## **Greens Reels #08-28**

## **Incorrect Location of Leak Detector Breather**

Product: Greensmaster® 3300 Dec 4, 2012

### **INCORRECT SET UP**

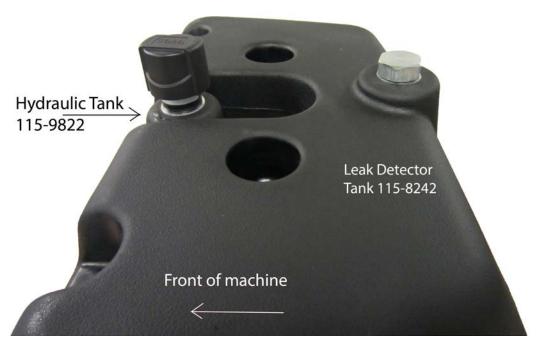
Hydraulic fluid residue could build up on the hydraulic tank from a leaking breather. The Breather (115-9793) on the Greensmaster® 3300 should be located on the Leak Detector Tank (115-8242) while a Plug (354-74) should be on the Hydraulic Tank (115-9822). Some units mistakenly had the breather installed on the hydraulic tank and the plug on the leak detector tank. Below is a picture of a breather installed incorrectly on the hydraulic tank. Note: Failure to make this change may cause a leak or prevent the leak detector to function properly.

If the breather is installed on the hydraulic tank, remove the breather from the hydraulic tank and remove the plug (using a 1-1/4" wrench) from the leak detector tank. Install the breather on the leak detector tank and install the plug on the hydraulic tank. Do not use a thread sealant. Below is a picture of a breather installed correctly on the leak detector tank.
